Service Bulletin

Bulletin No. 2005-11

30-60 Horsepower FourStroke Voltage Regulator Replacement Models Affected

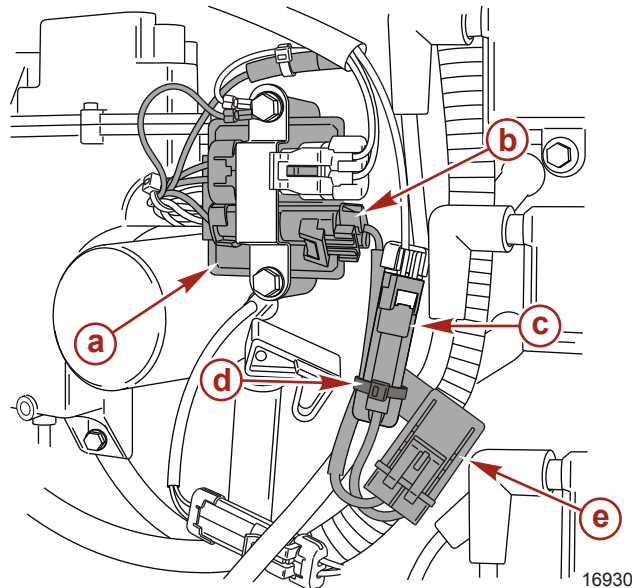
Mercury Marine has received reports of voltage regulator failures on the above identified models. A failure of the voltage regulator will prevent the battery from maintaining a proper charge. Included in the observed failure modes is electrical arcing within the regulator, which can be an ignition source. Mercury Marine has made changes to the voltage regulator, and related components, to address this issue. The models identified above will be upgraded, at no cost to the customer, with a kit (described below), which includes a new voltage regulator.

Inspect the engine for the installation of a fuse harness (c) required for the use of this new kit. If the fuse harness is installed, the bulletin has been performed on the engine and no further action is necessary.

- a** - Voltage regulator
- b** - Fuse harness connector to voltage regulator
- c** - Fuse harness connector to wiring harness
- d** - Cable tie securing fuse and harness
- e** - 25 ampere fuse assembly

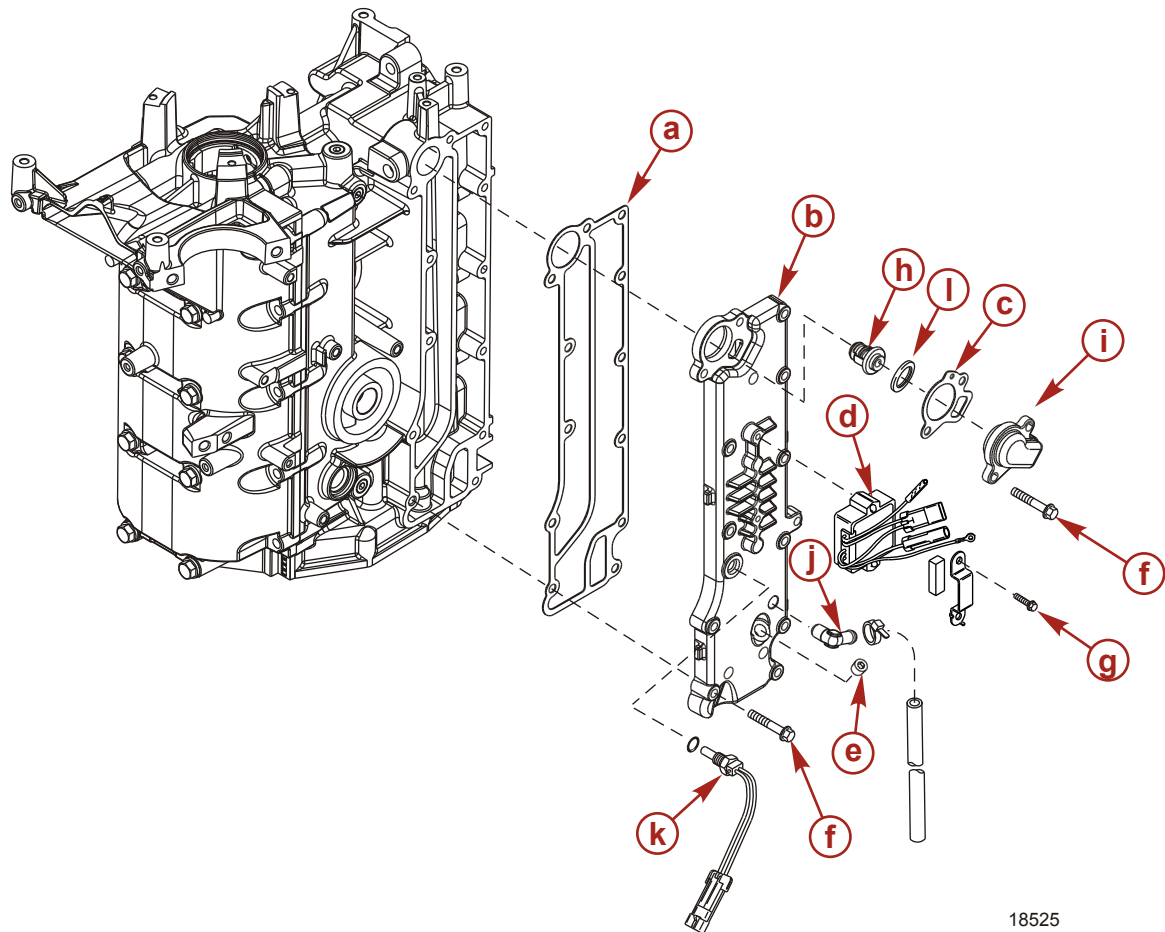
NOTE: The installation of this kit requires the replacement of the engine exhaust cover. Refer to the appropriate service manual for removal and installation instructions.

- a - Exhaust cover gasket

b - Exhaust cover

c - Thermostat cover gasket

d - Voltage regulator

e - Pipe plug (drive tight)

f - Screw (M6 x 35) (12 each)
- g - Screw (M6 x 40) (2 each)

h - Thermostat

i - Thermostat cover

j - Elbow

k - Temperature sensor

l - Thermostat gasket

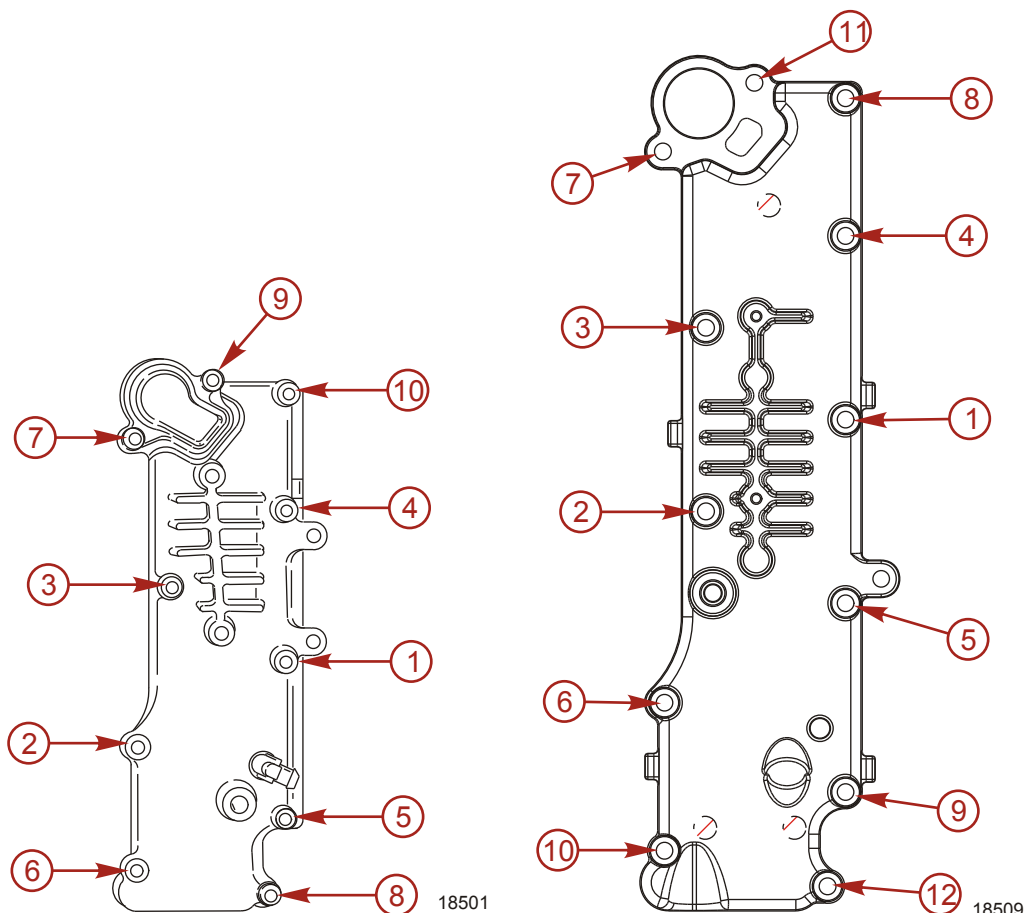
13. Torque the exhaust cover and thermostat cover screws in the proper torque sequence. Reference the correct sequence below.

Description		Nm	lb. in.	lb. ft.
Exhaust cover screw torque	First	6	53	
	Final	12	106

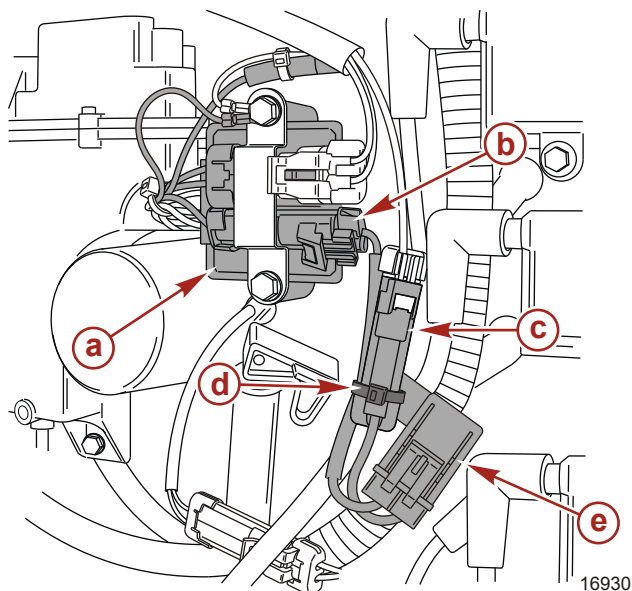
17. Route and secure wiring as shown.

- a** - Voltage regulator
- b** - Fuse harness connector to voltage regulator
- c** - Fuse harness connector to wiring harness
- d** - Cable tie securing fuse and harness
- e** - 25 ampere fuse assembly
